We would like to inform you that the support wheel console dedicated to KFGL35-A devices has been modified and will now be offered in a "skewed" version by 15 degrees. This position allows the support wheel to be mounted as close as possible to the longitudinal axis of the trailer while maintaining a safe distance between the wheel and the brake rod. This solution allows you to focus less on the position of the wheel forks when lifting the wheel to the driving position without the risk of damaging the brake rod.

Art. No 210546.xxx

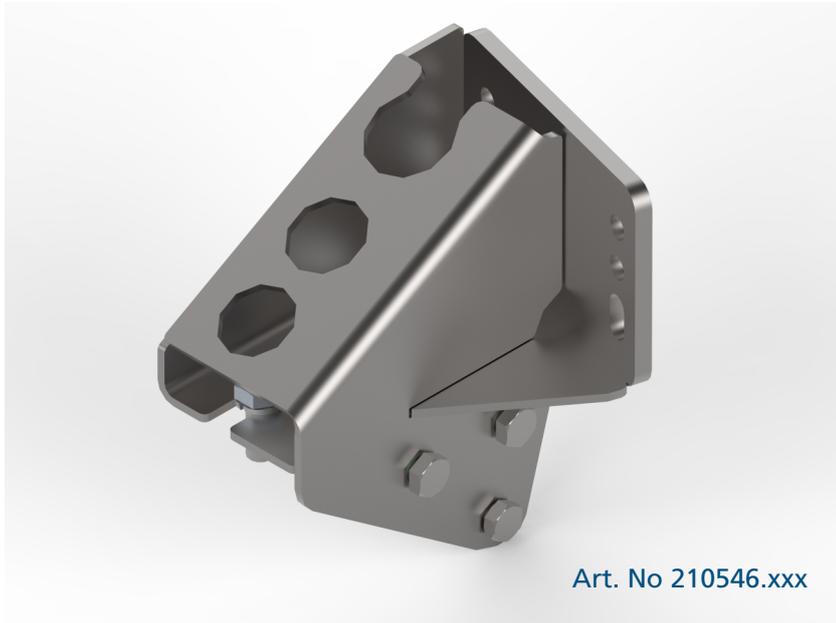
The overrun device can be equipped with a console at every stage of the product's life.

Fixing a new type of console to the device is similar to the previous version, so it is possible to replace the old console with a new one.

Art. No 210547.xxx

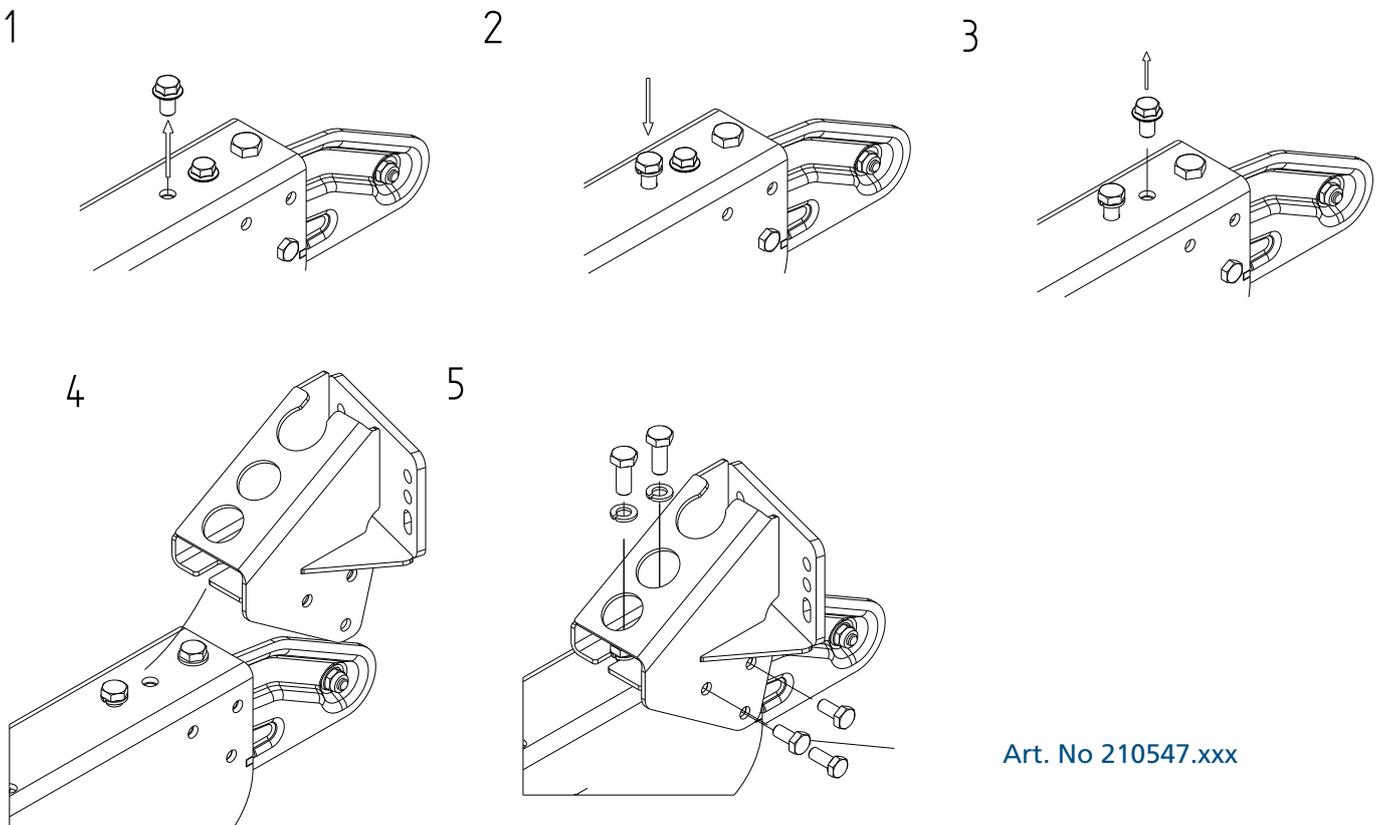
Below we present the method of mounting the console on the casing of the overrun device.

A new type of console allows you to bypass the brake rod when lifting the support wheel.

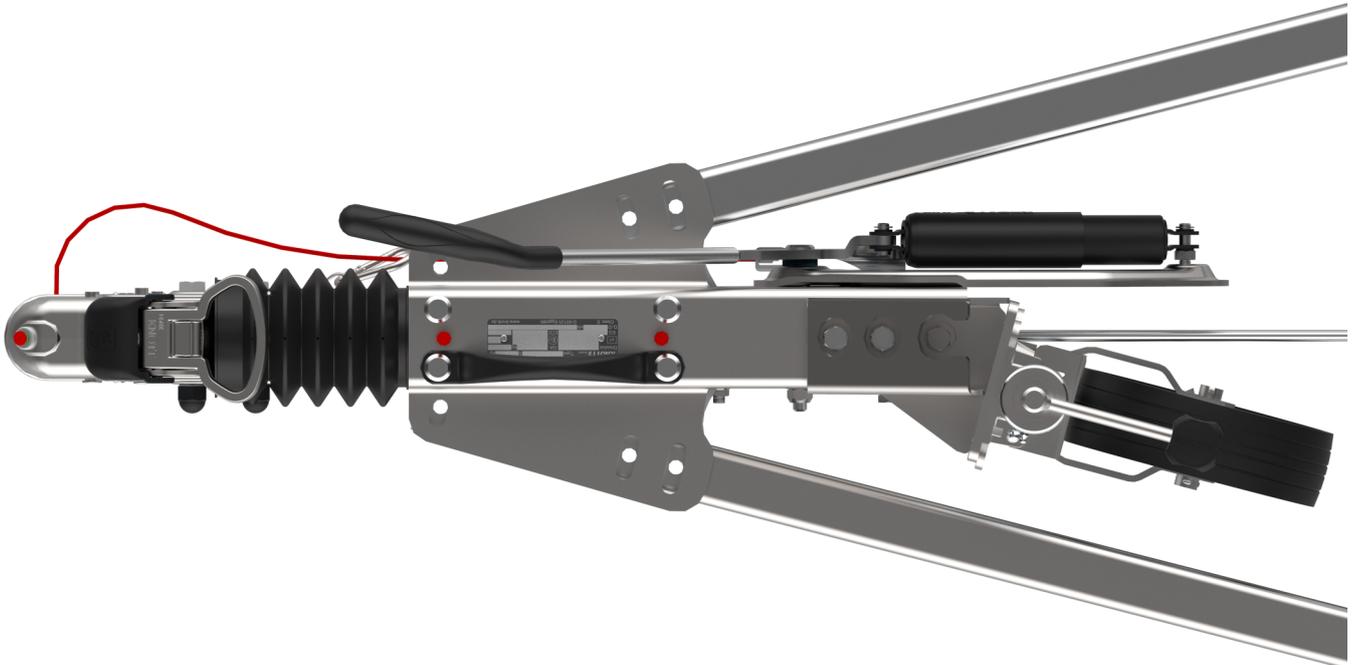
The photo below shows the new console on the overrun device in top view.

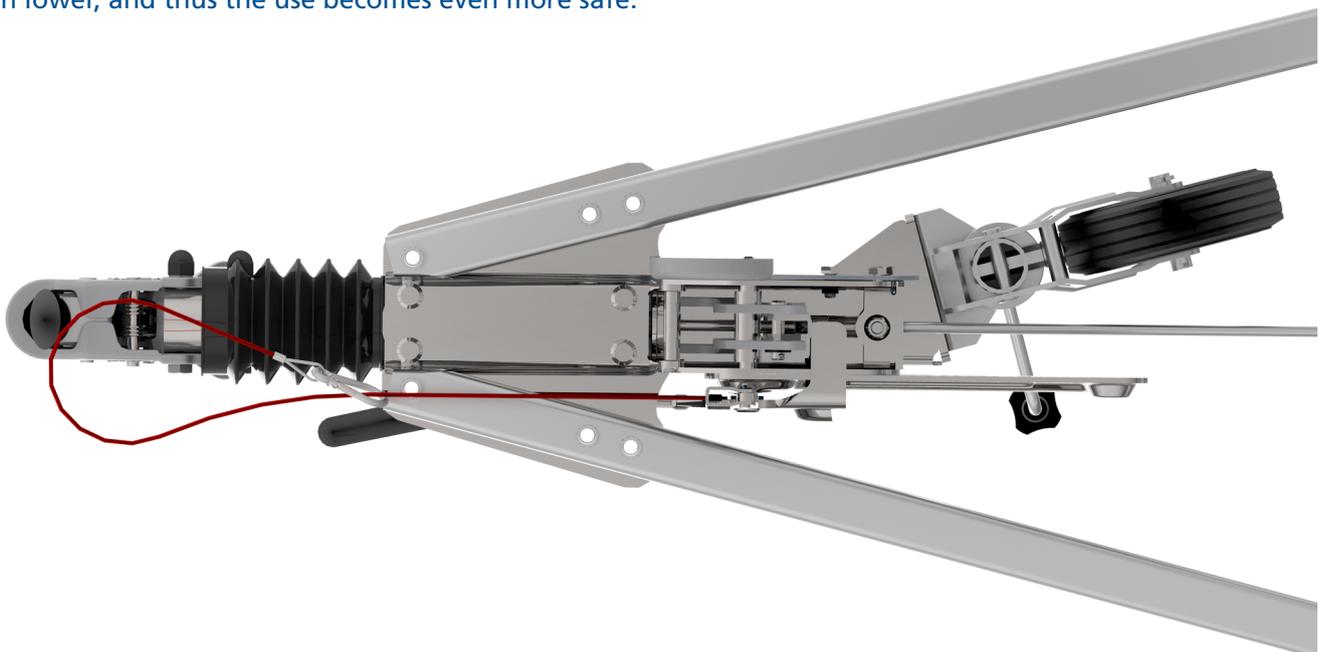
Below we present an example of the use of the device with a new type of bollard in the view from the bottom of the trailer.

It is clear that thanks to the console adjustment by 15 degrees, the risk of a collision with the brake rod is much lower, and thus the use becomes even more safe.

Modification of the console by turning it by 15 ° does not limit the available space and the angle of the drawbar arms, so it will not cause problems for the existing structures of trailers.

Due to the introduced change, the support wheel can be lowered more easily into the support position.

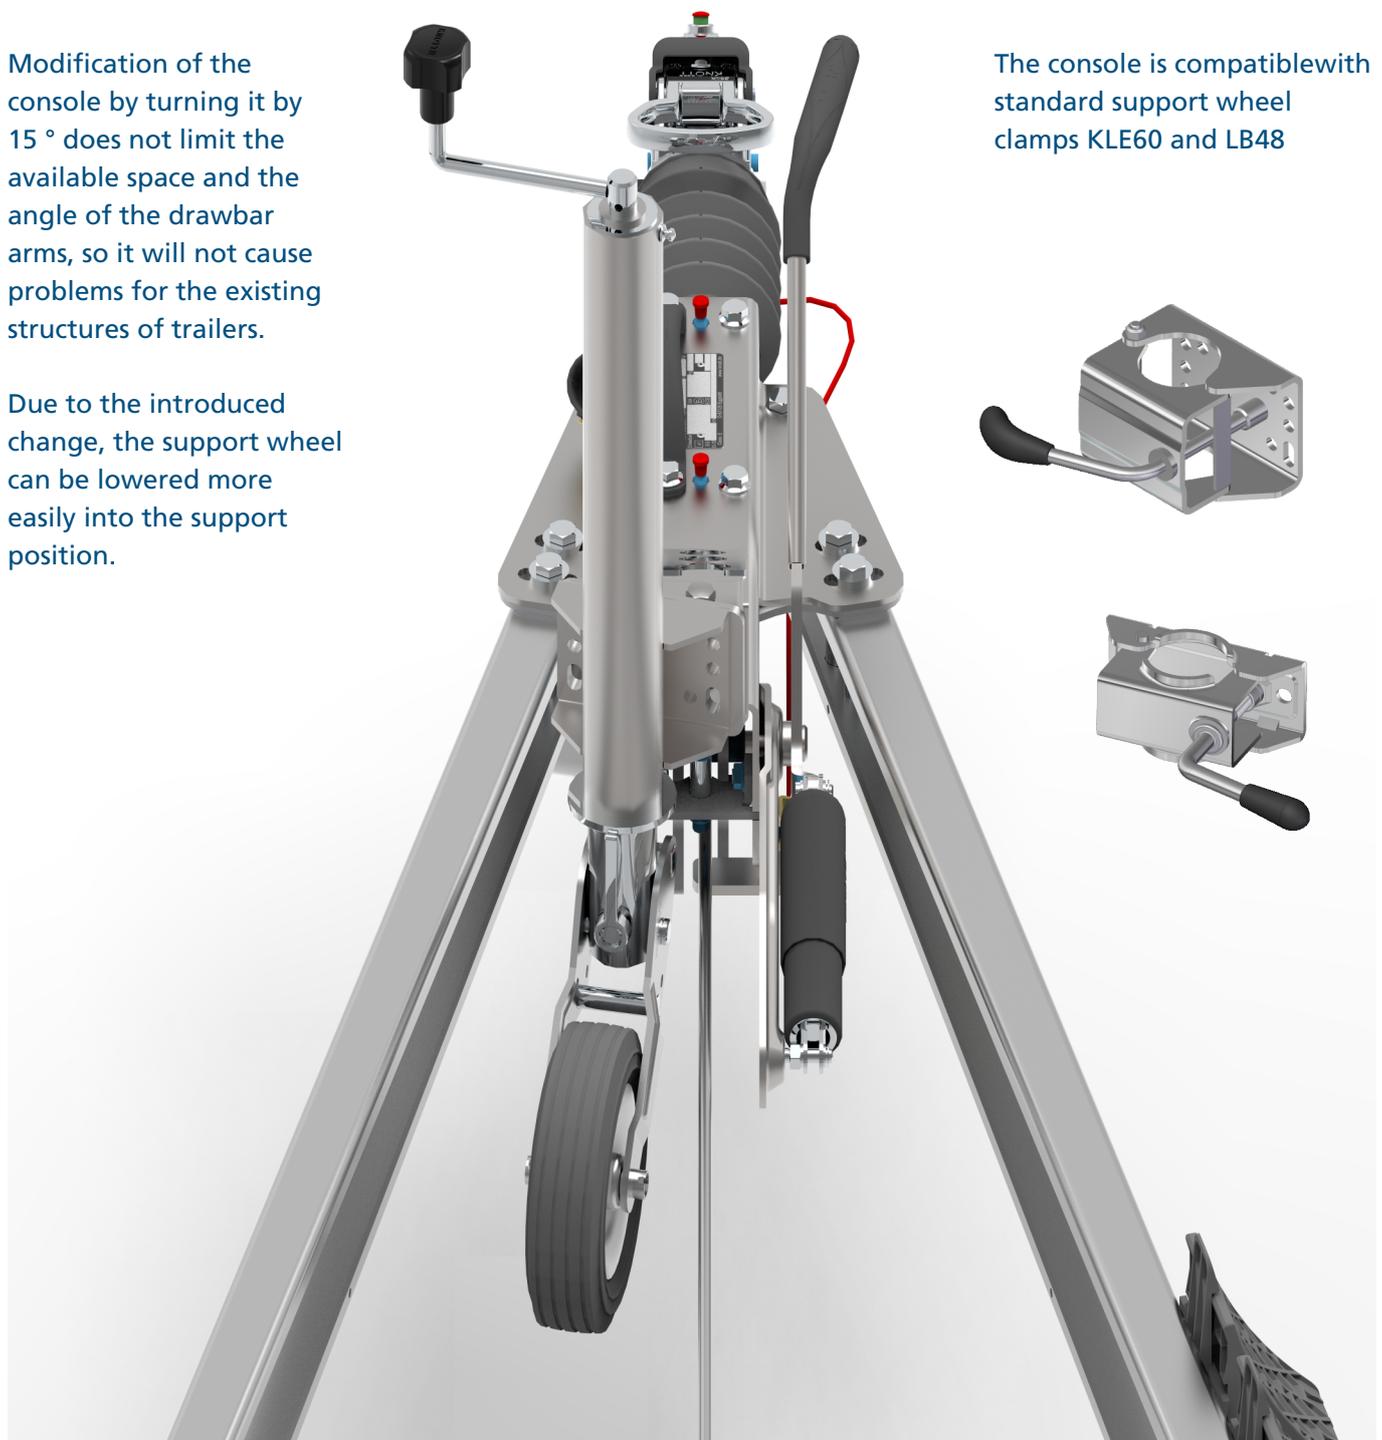
The console is compatible with standard support wheel clamps KLE60 and LB48

The ATK60 support wheel in the position supporting the trailer shows that there is no possibility of damage, bending or only contact of the brake rod with the wheel.

KFGL35-A overrun device with a console set at an angle of 15 degrees.

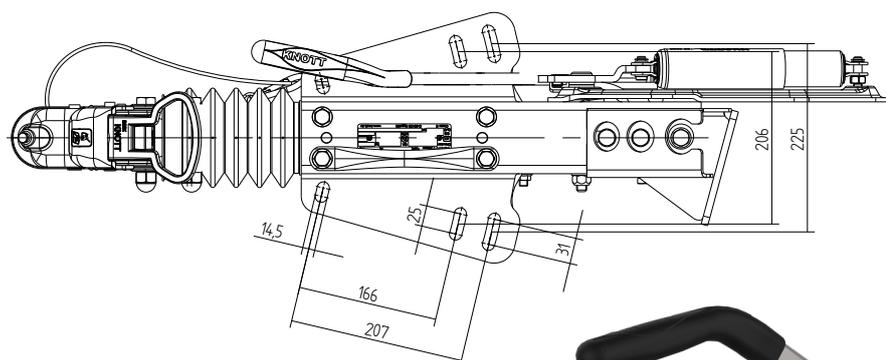
KFGL35-A overrun devices with console are also offered with the new version of the console. We encourage you to contact the representatives of the sales department for details.

The console, apart from changing the position, has the same parameters as the previous versions.

Art. No 204532.xxx

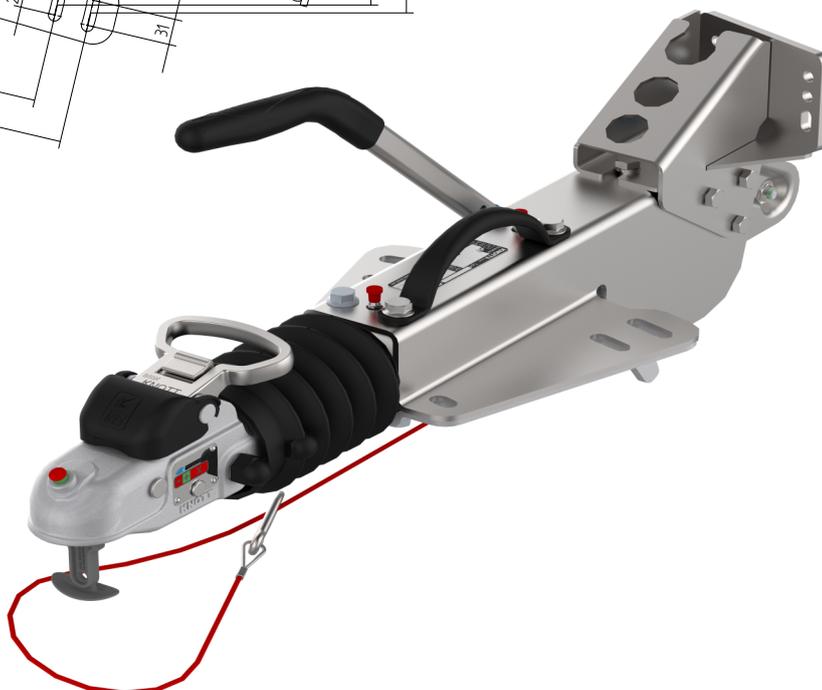
The connection of the support wheel console is identical, thanks to which it is possible to install the same support wheels as in any other KNOTT overrun device.
